REDLAND RIDGE SUBDIVISION
PRELIMINARY OVERALL AREA DEVELOPMENT PLAN

Re: Redland Ridge

POADP # 608

Reference: Redland Ridge Subdivision P.O.A.D.P.

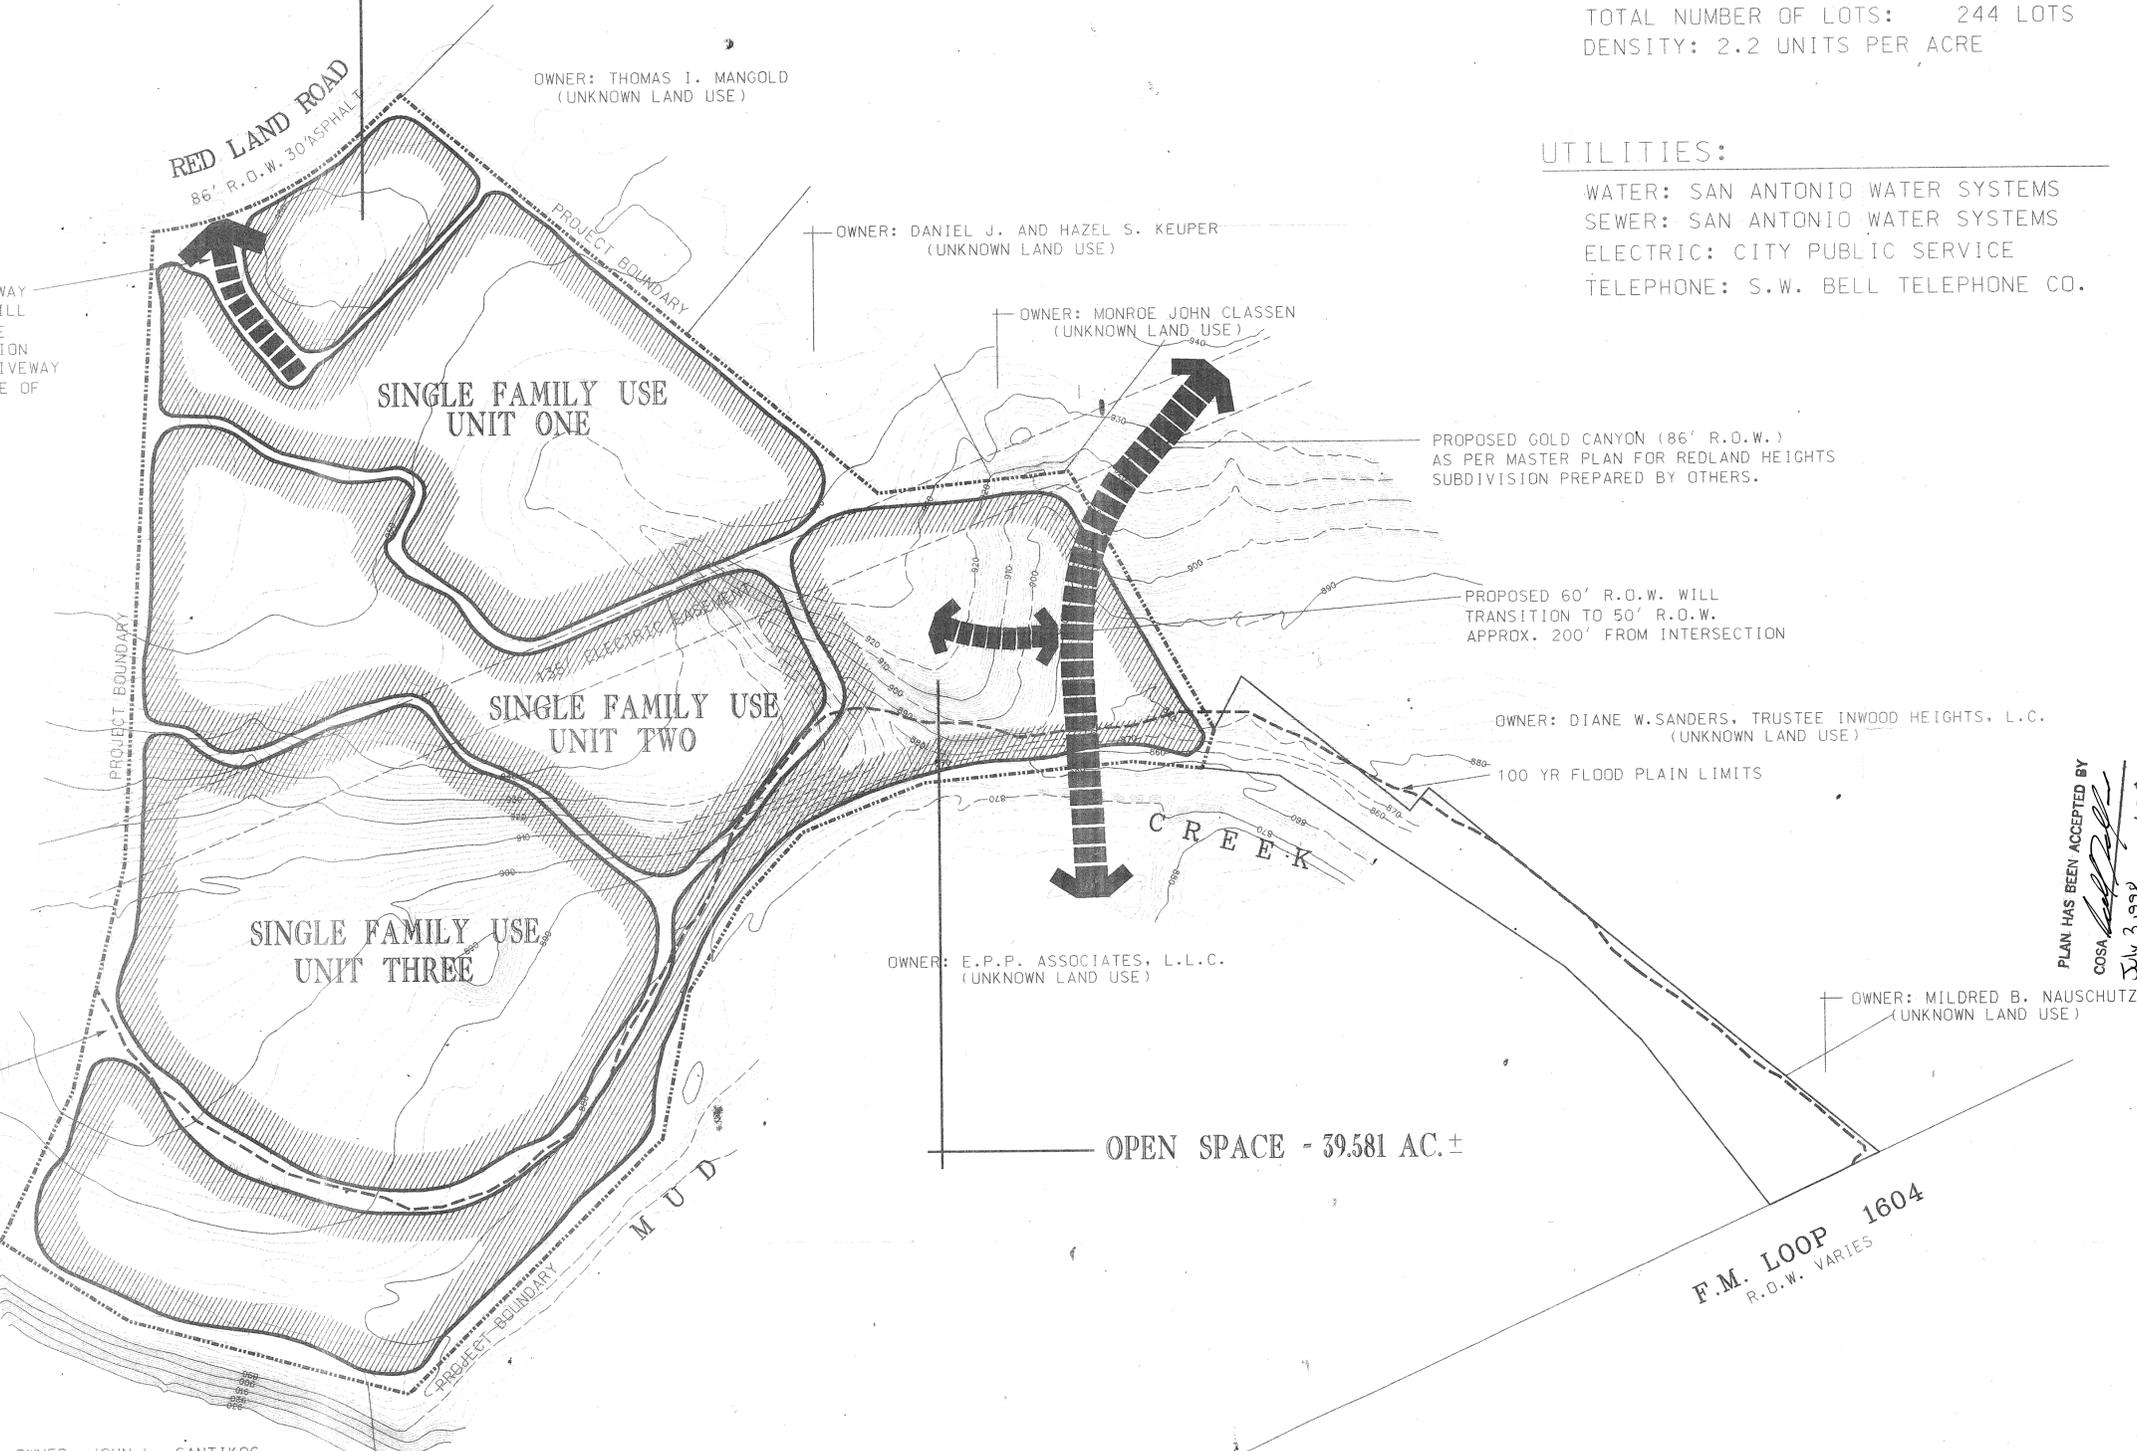
The City Staff Development Review Committee has reviewed Redland Ridge Subdivision Preliminary Overall Area Development Plan # 608. Please find enclosed a signed copy for your files. Although your plan was accepted, please note the following:

- Based on the topography, a Flood Plain Study and drainage review will probably be required during the platting process.
- This development will probably need to conform to requirements associated with development over the Edwards Aquifer. For information about these requirements you can contact SAWS at 704-7305.
- This development will need to comply with tree preservation ordinance #85262. For information about these requirements you can contact Building Inspections at 207-7102.
- It will be expected that you will plat all of the property depicted in your POADP, to include: floodpains, drainage areas and open space.
- I would encourage you to work closely with the school district, so that they can plan accordingly.

Submitted herewith, is a revised POADP for Redland Ridge Subdivision. The revisions to the P.O.A.D.P. are per your initial review of the Plan.

i) The proposed street alignment of Gold Canyon Dr. as per major thoroughfare plan, has been added.

ii) Location of driveway curb cut locations on divided roadway and 60 foot right of way (local type 'B') roadways. The location of the driveway curb cut locations will be determined when a final lot design for the subdivision is completed.

iii) Secondary Entrance. A second entry into the subdivision, can be achieved by accessing proposed Gold Canyon Dr. A second entry via Redland Road is prohibited by the location of a sink hole within the area identified as an open space.

iv) A traffic impact study will submitted to Traffic Dept. for their review.
